AA.23.33.27 Immingham Green Energy Terminal

Prepared for: Becky Garrett
Prepared by: Harry Robinson (SYSTRA)
Date: 12th March 2024
Case Reference: DevHU0144
Document Reference: DevHU0144 003 TM Final
Reviewed/approved by: Terry Dale (SYSTRA)

Figure 2. ABP construction worker trip distribution

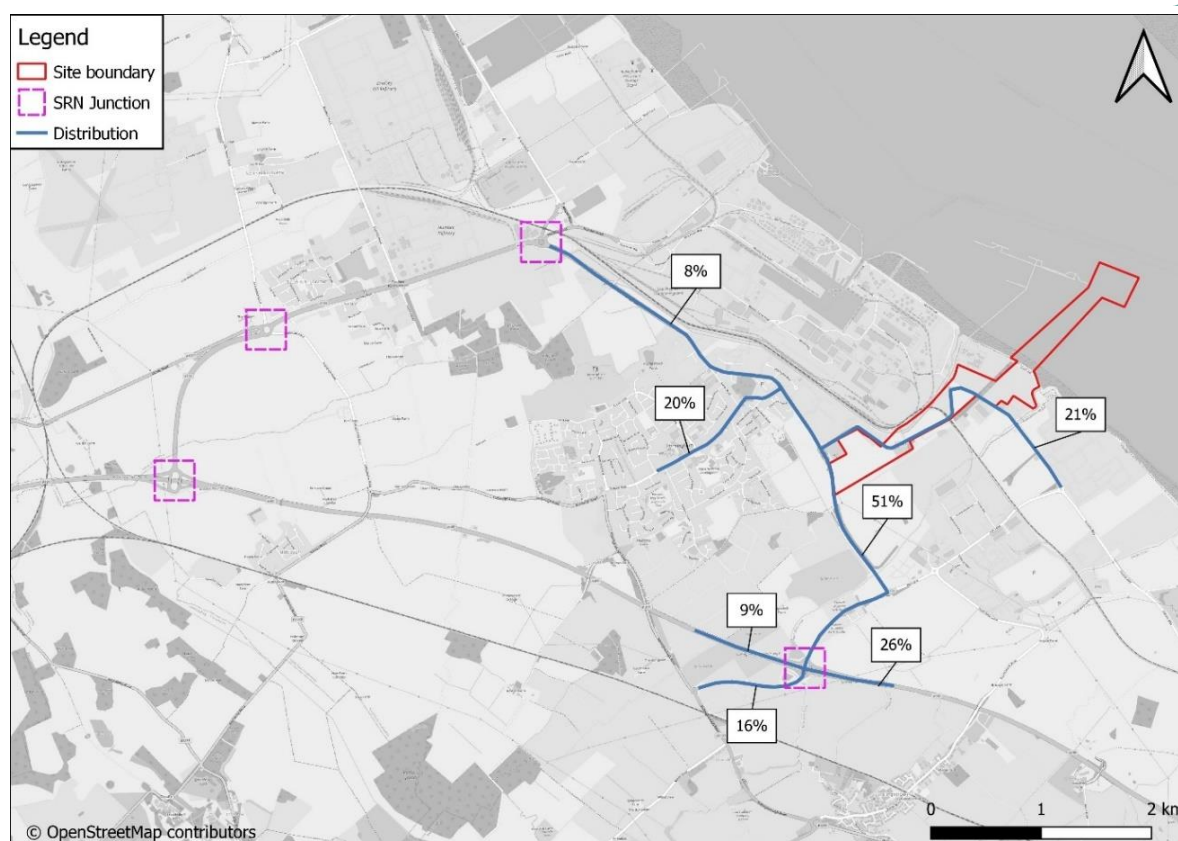
JSJV would note that 51% of construction worker vehicle trips are assigned to the A180/A1173 junction, 9% to/from the west, 26% to/from the east and 16% to/from the south.

As shown in **Table 2**, DTA has assigned the construction worker vehicle trips across the A180/A1173 based on the vehicle trip distribution presented in Figure 2.

Figure 3. Google Maps typical traffic AM peak

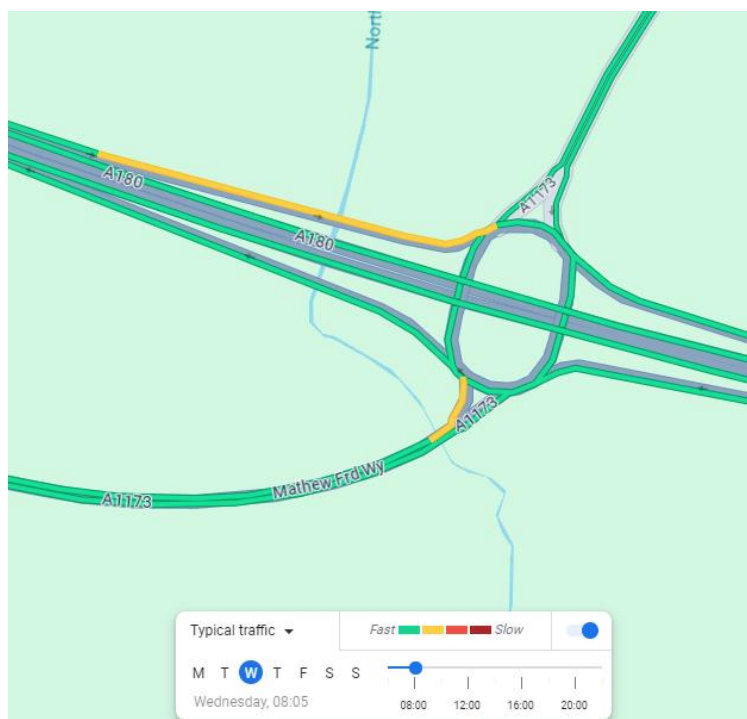
We have reviewed the performance of the junction based on typical traffic data obtained from Google Maps. It is seen that the AM peak experiences a short period of slow moving traffic on the A180 eastbound off-slip as shown in **Figure 3**.

Figure 4. Google Maps typical traffic PM peak

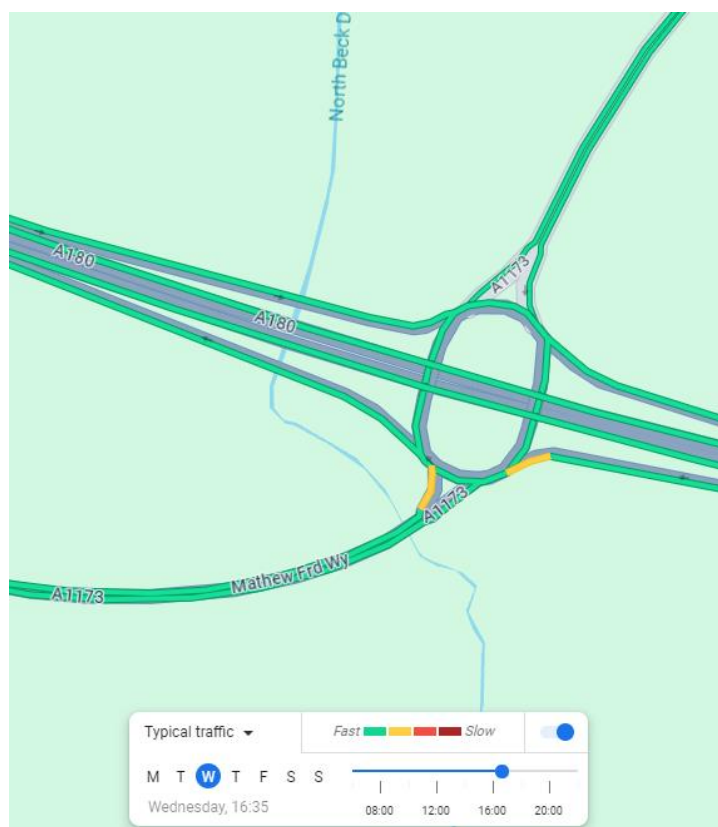
There is negligible delay experienced during the PM peak as shown in **Figure 4**.
